DEPARTMENT OF HOUSING AND COMMUNITY DEVELOPMENT

2024 Virginia Uniform Statewide Building Code Base Document

6/6/2025

Part I Construction

FIGURE 1609.5 TORNADO-PRONE REGION

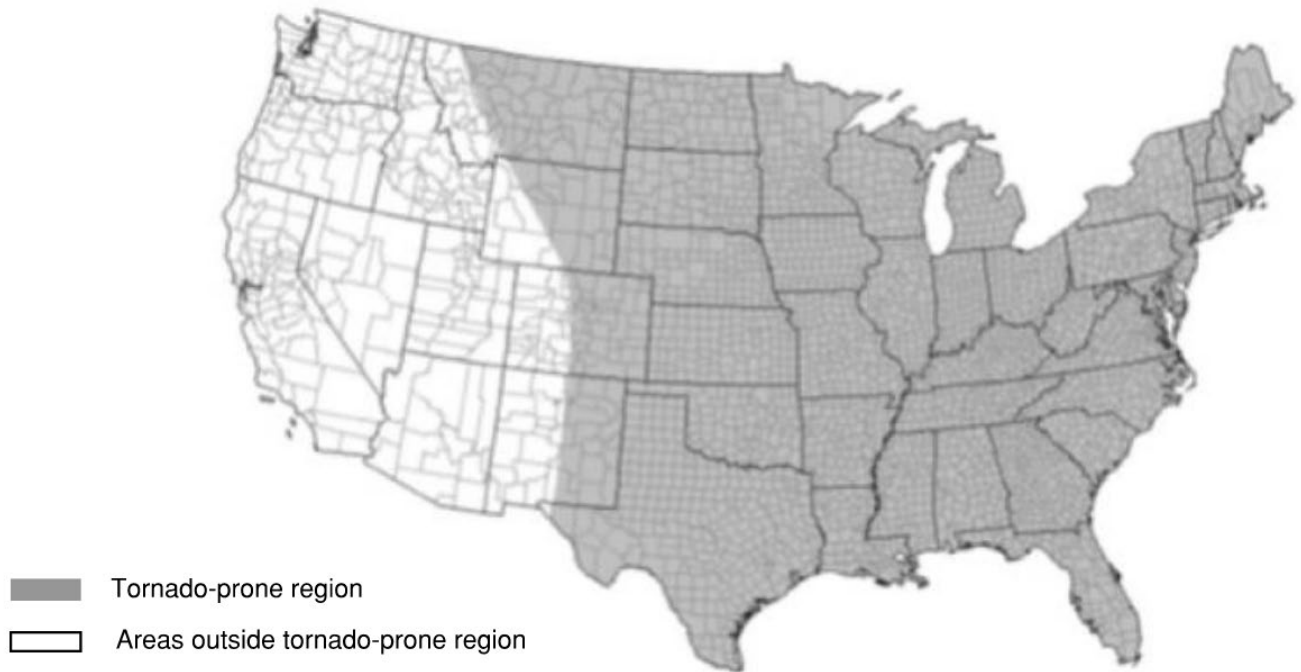
1609.5 Tornado loads. The design and construction of Risk Category ~~III and IV~~ buildings and other structures located in the tornado-prone region as shown in Figure 1609.5 shall be in accordance with Chapter 32 of ASCE 7, except as modified by this code.

G. Add Figure 1609.5 Tornado-Prone Region to the IBC.
